City of El Paso – City Plan Commission Staff Report

Case No:	SUSU14-00109 – Desert Springs Unit 4
Application Type:	Major Combination
CPC Hearing Date:	December 4, 2014
Staff Planner:	Joaquin Rodriguez, (915) 212-1608 rodriguezjx3@elpasotexas.gov
Location:	North of Transmountain East of I10
Acreage:	63.08
Rep District:	1
Existing Use:	Vacant
Existing Zoning:	R-3A (Residential)
Proposed Zoning:	R-3A (Residential)
Nearest Park:	Desert Springs Park (.15 mi)
Nearest School:	Alderette Middle (1.3 mi.)
Park Fees Required:	None
Impact Fee Area:	West Side Impact Fee Area
Property Owner:	DVEP Land LLC RPW Developement City of El Paso
Applicant:	DVEP Land LLC
Representative:	CEA Group

ATTACHMENT 3

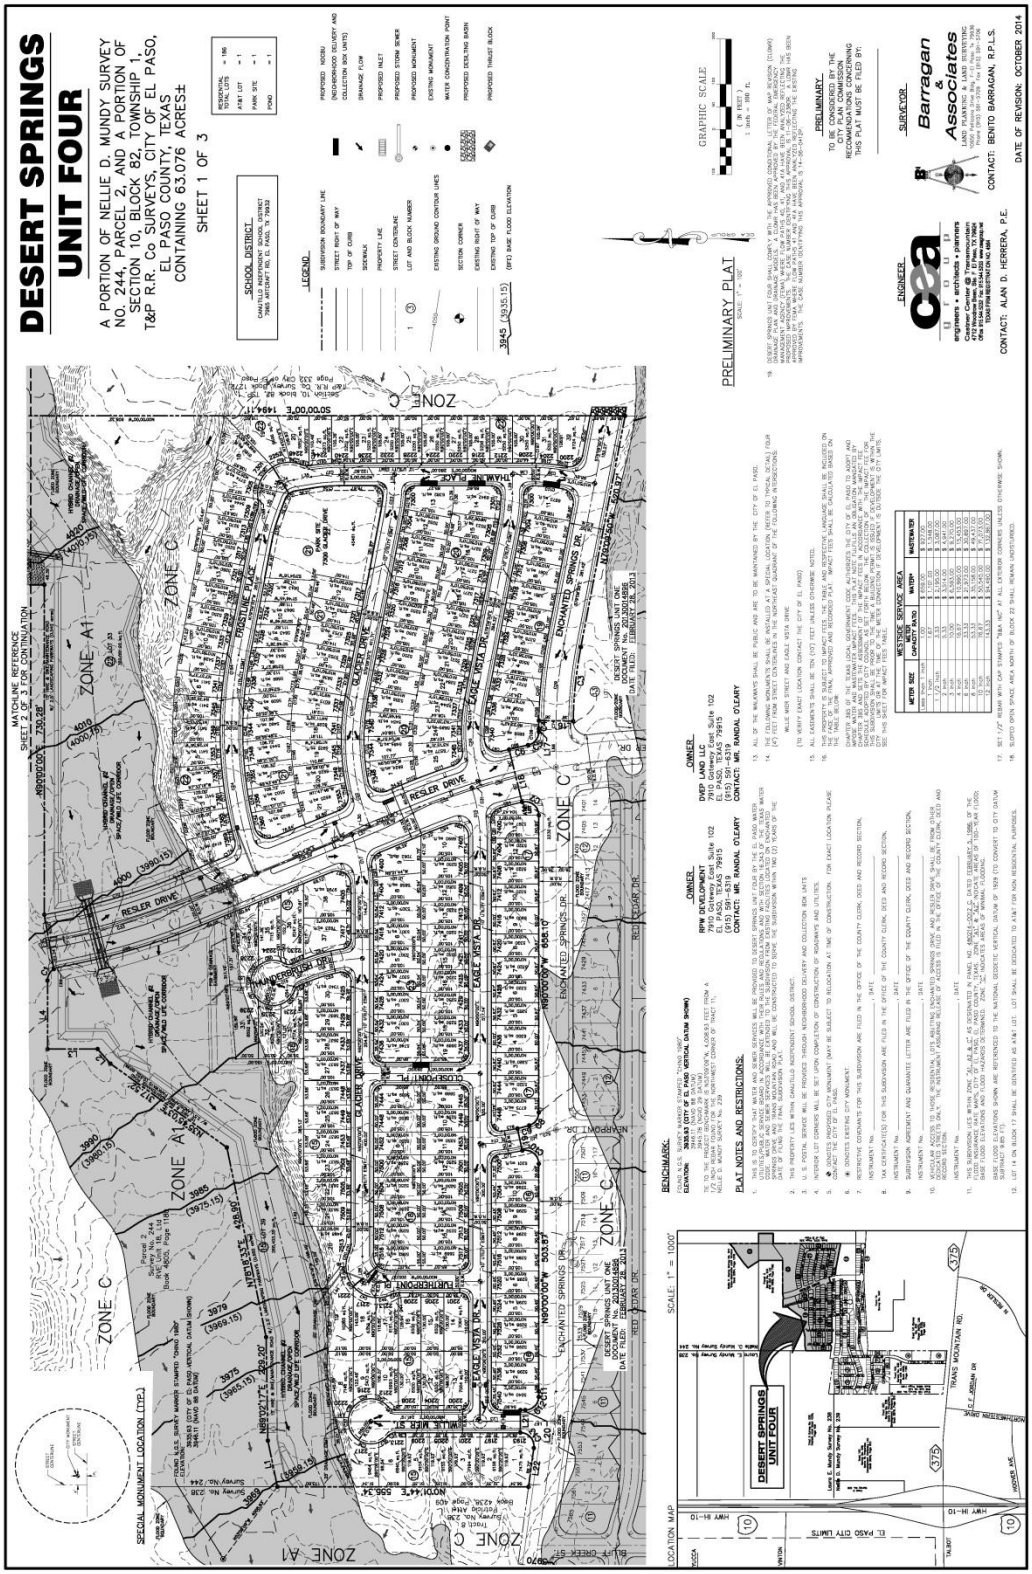
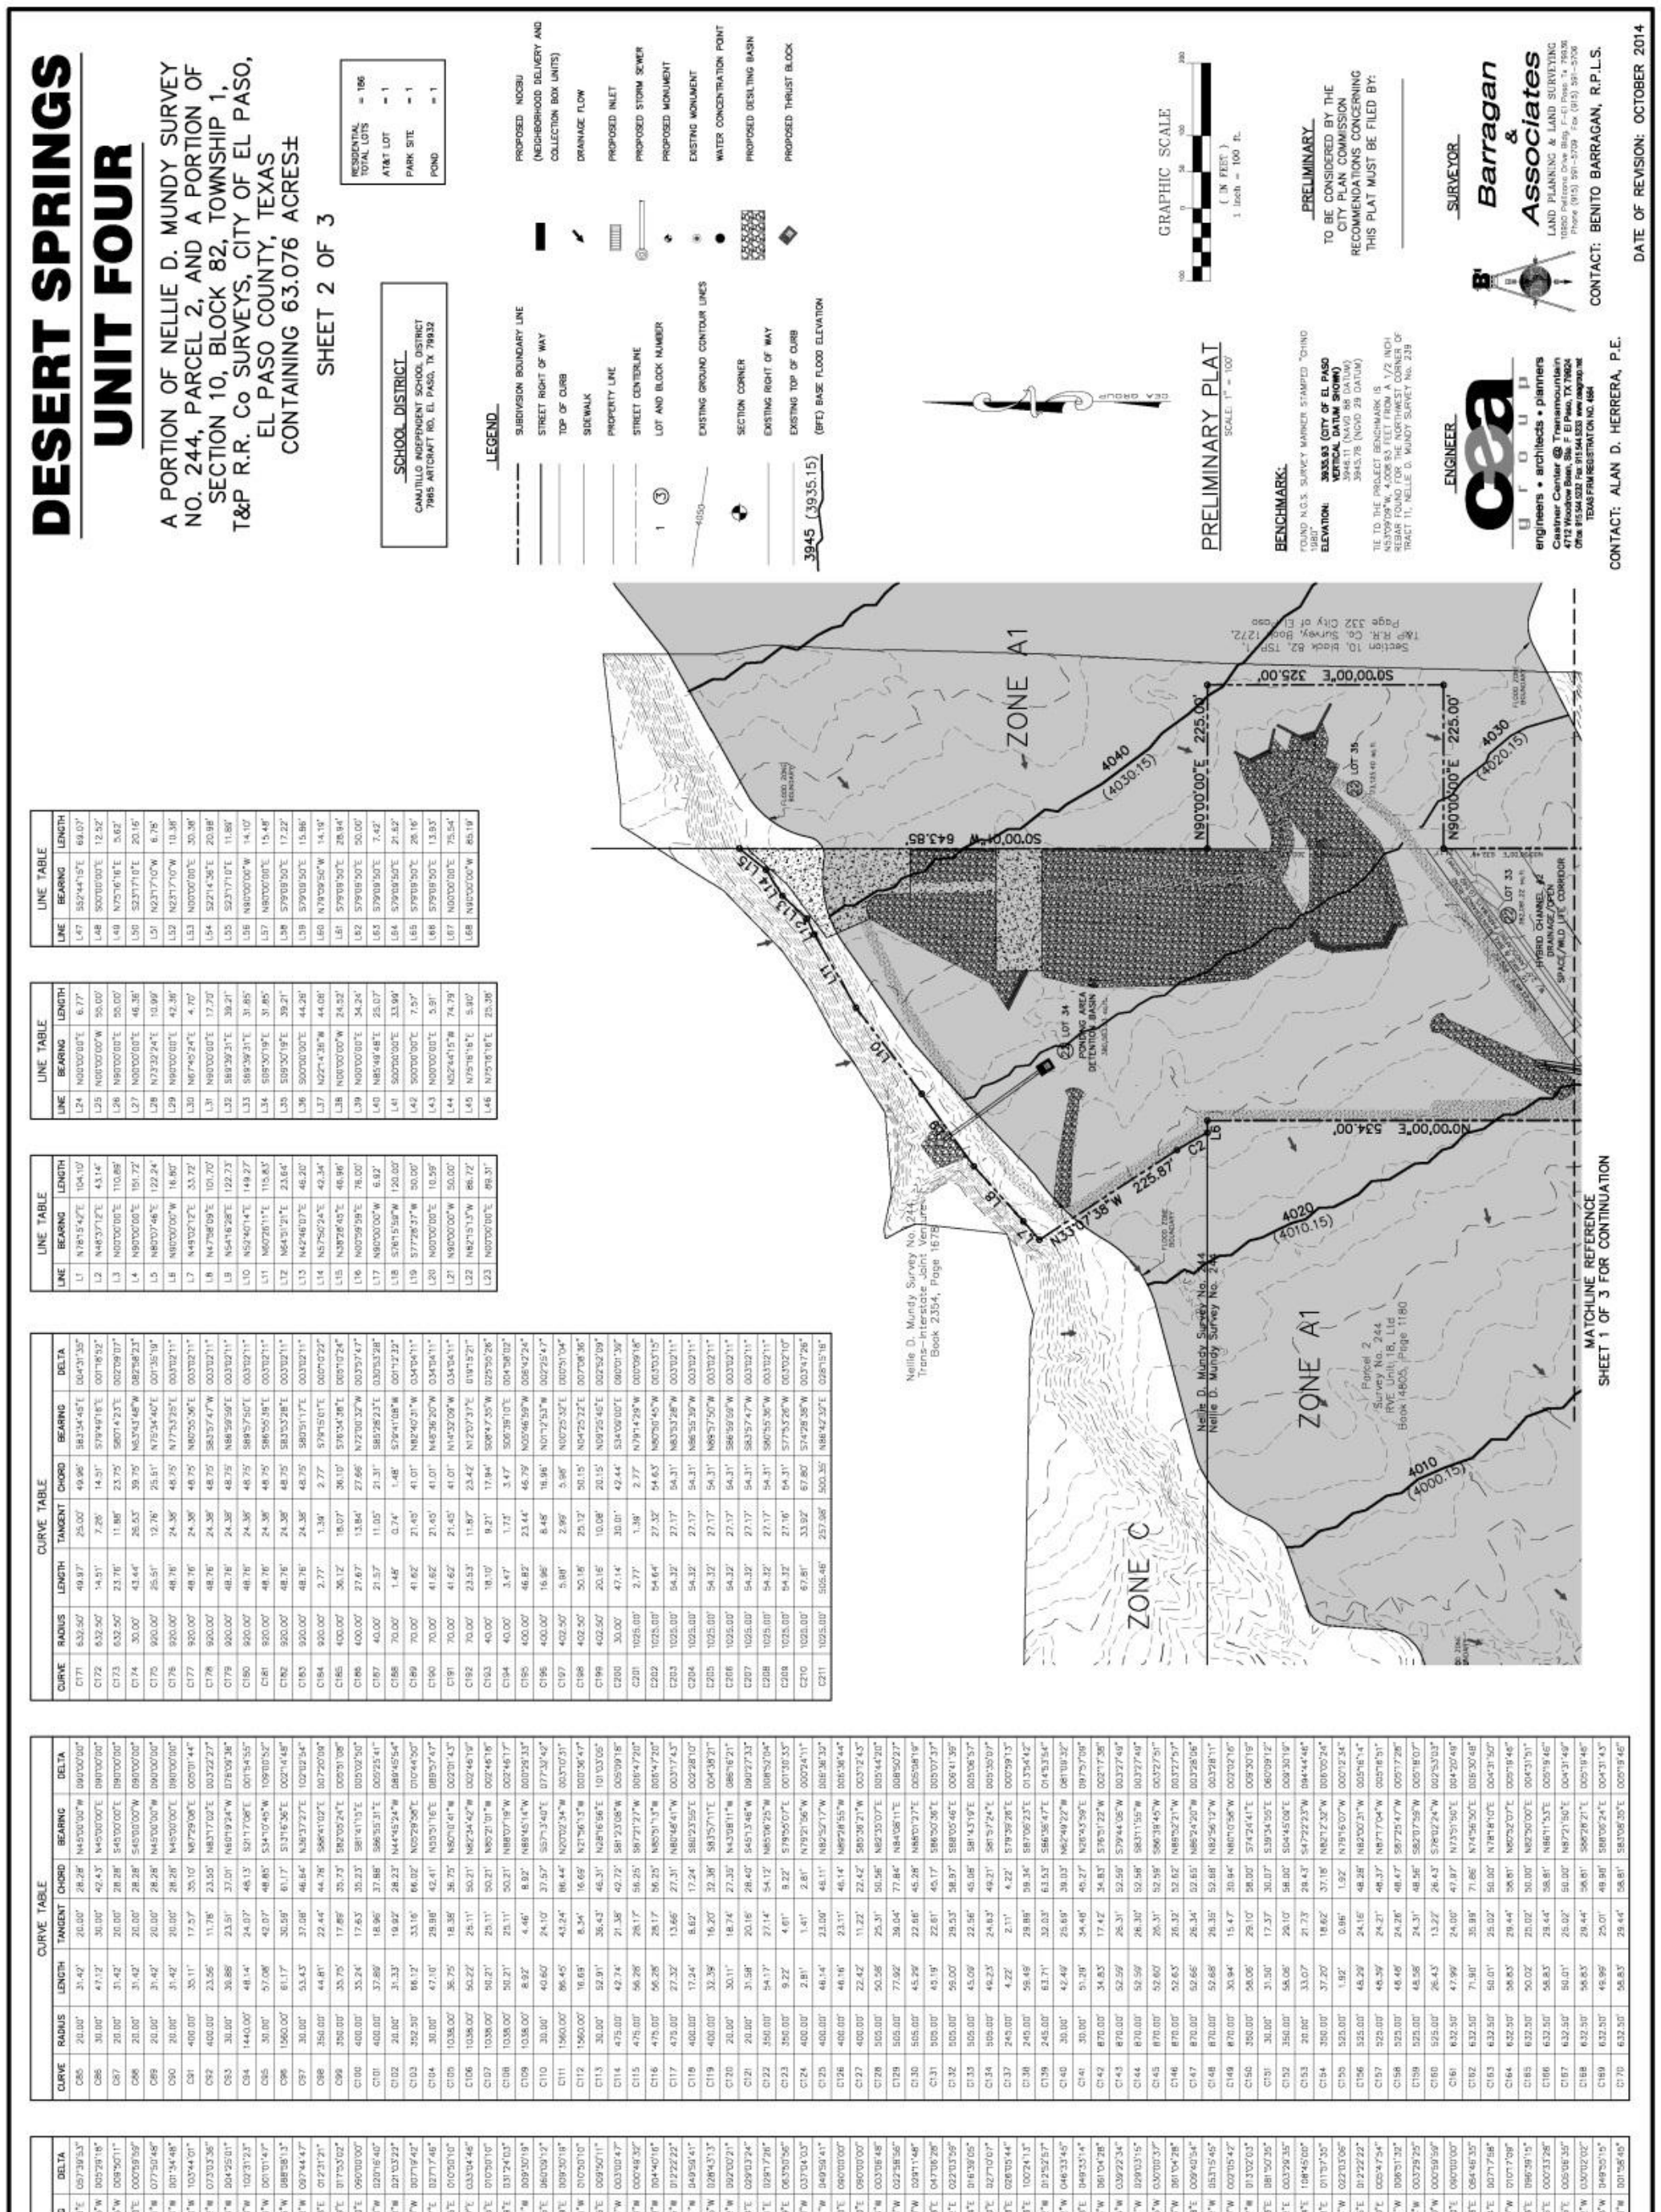
Show and label all existing street and drainage improvements, drainage flow patterns and label existing contours on preliminary plat.

1. Eliminate PSB easement within Lot 34, Block 15; sewer to be designed to avoid easement thru property.

ATTACHMENT 6

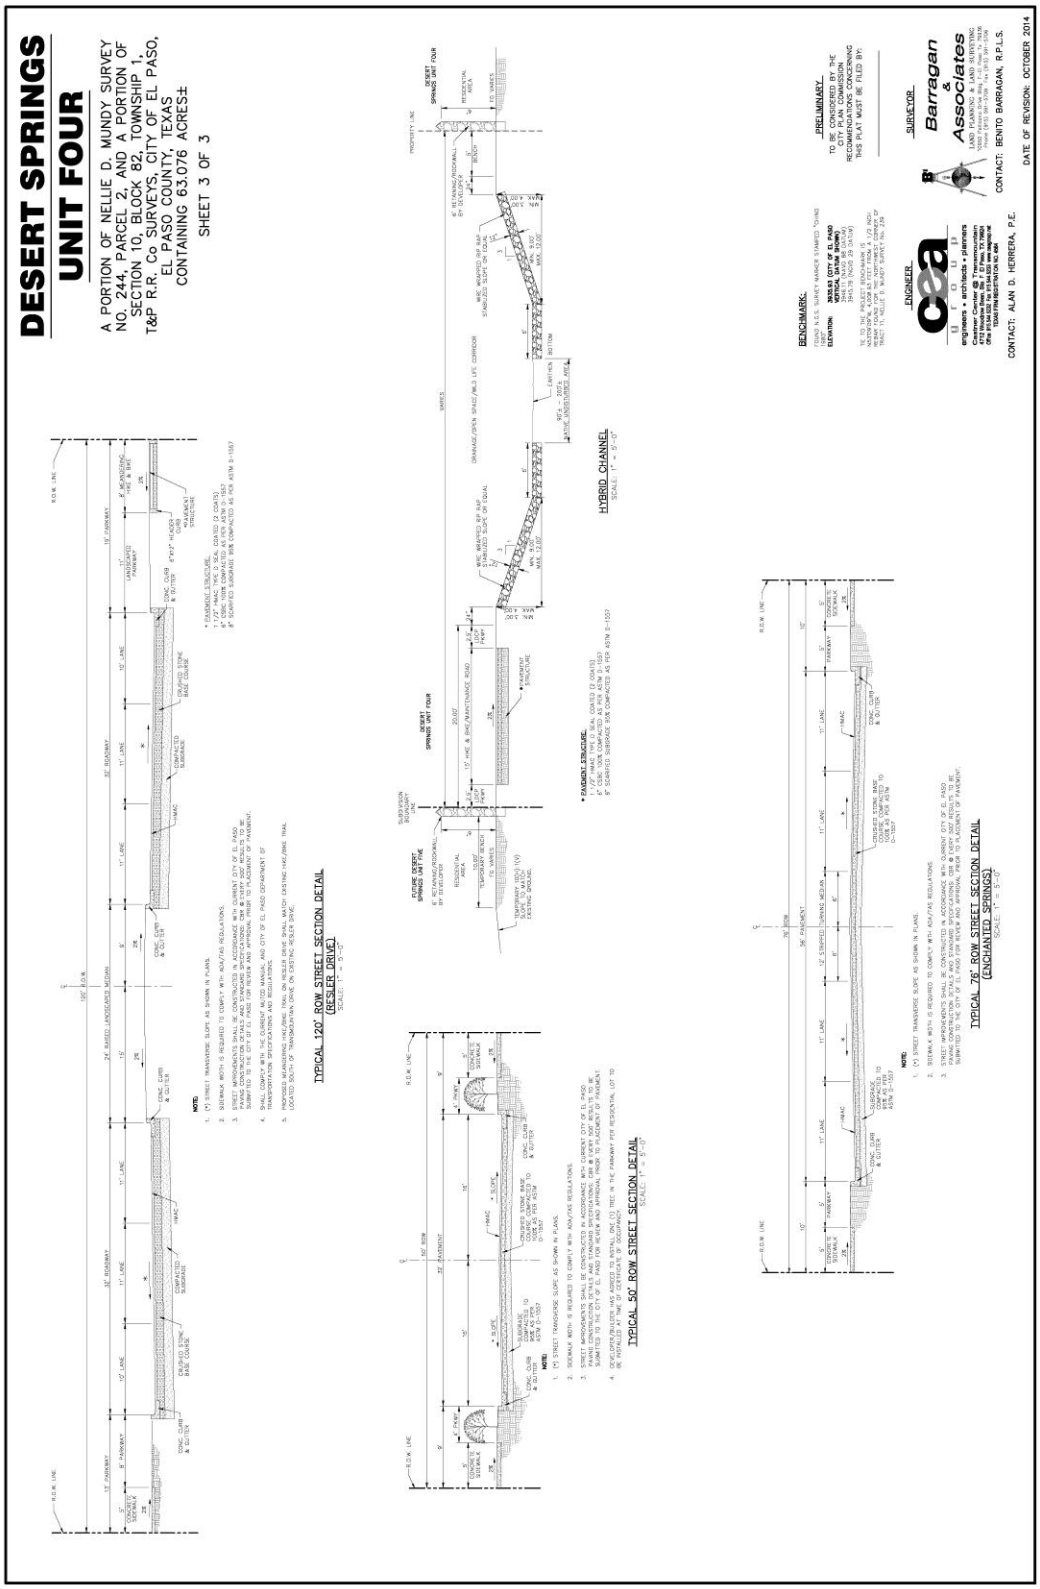
Modification No. 1: 50' R.O.W. Street
A modification to reduce right-of-way width from fifty-two (52') feet to a typical fifty (50') feet is also requested. The typical fifty (50') foot right-of-way shall consist of thirty-two (32') feet of pavement with sixteen (16') feet from center, two nine (9') foot parkways with five (5') foot sidewalks and six (6") inch standard curb and gutter.

Modification No. 3: 76' R.O.W. Street
A modification to maintain consistency on a previously approved section that includes a seventy-six (76') foot right-of-way width is also requested. The typical seventy-six (76') foot right-of-way shall consist of fifty-six (56') feet of pavement with twenty-eight (28') feet from center, two five (5') foot parkways with five (5') foot sidewalks and six (6") inch standard curb and gutter.

Modification No. 4: 120' R.O.W. Street
A modification to maintain consistency on a previously approved right-of-way for the one-hundred-and-twenty (120') feet is requested. The one-hundred-and-twenty (120') foot modified right-of-way shall consist of thirty-two (32') feet of pavement (two eleven [11'] foot and one ten [10'] foot lanes) on both sides of the twenty-four (24') foot raised median. The center of the roadway (including the raised median) shall be offset three (3') feet from the right-of-way centerline. This shall provide a thirteen (13') foot parkway with a five (5') foot sidewalk and on the other side of the raised median a nineteen (19') foot parkway with an eight (8') foot meandering hike and bike trail. Our request for the right-of-way modification is based on Park's Department recommendation to extend and connect the existing hike and bike trail along Resler Drive.
